SUBJECT: TRIP REPORT – APRIL 18 – 19, 2011, GEOLOGY SITE VISIT AND AUDIT  
IN SUPPORT OF THE V.C. SUMMER COMBINED LICENSE APPLICATION

This report summarizes the NRC site visit to the V.C. Summer Nuclear Station (VCSNS) Units 2 and 3 excavations and the surrounding area during the period of April 18, and 19, 2011. An audit plan was developed to support the site visit in accordance with the Office of New Reactors (NRO) Office Instruction NRO-REG-108, "Regulatory Audits." The Audit plan is available in Agencywide Documents Access and Management System (ADAMS) under accession number ML110871115. The purpose of the site visit was to:

Figure 4 – Unit 2 Probable Minor Shear

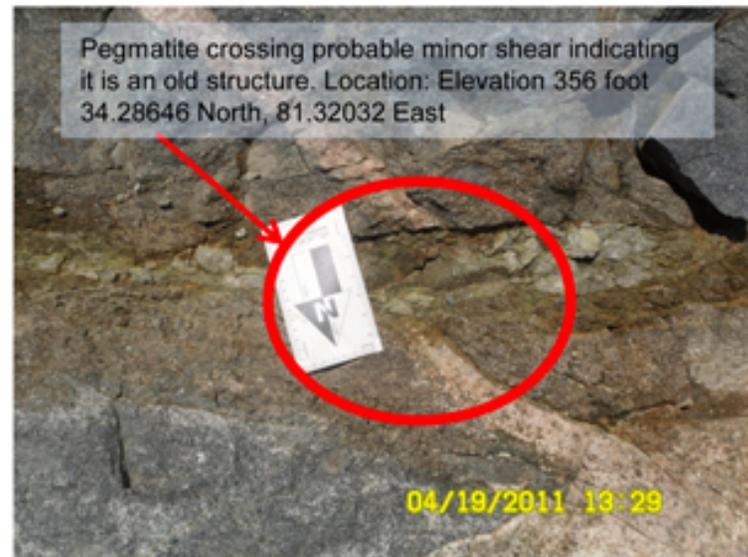
Figures 1 through 4 of Enclosure 3 are images provided to the NRC staff by SCE&G prior to the April 18-19, 2011, NRC site visit. Figures 1 through 3 are overview images showing rock units exposed in the Unit 2 excavation in April 2011, looking west, east, and north, respectively. Figure 4 of Enclosure 3 is a close-up image of a probable minor shear zone that was determined by the applicant to be the same shear zone as that which NRC staff identified in Figure 5 of the NRC's August 30, 2010, trip report. Specifically, as removal of rock materials above the foundation grade level progressed, the applicant was able to trace the shear zone vertically downward from the sound rock surface examined during the August 2010 site visit to the foundation grade level examined by the staff during the April 2011 site visit. (The staff observed and confirmed the field relationships used by the applicant to determine that the shear zone extended vertically downward from the higher level to foundation grade level during the April 2011 site visit.) In addition, similar to the observations presented in the August 30, 2010, trip report, based on geologic field relationships related to cross-cutting igneous veins that are not offset by the shear zone, the staff concludes that the minor shear zone shown in Figure 4 of Enclosure 3 does not represent a capable tectonic structure in the foundation bedrock. The applicant also indicated that radiometric age dates would be acquired on undeformed minerals growing in the shear zone that represent deep-seated hydrothermal conditions which are very much older than
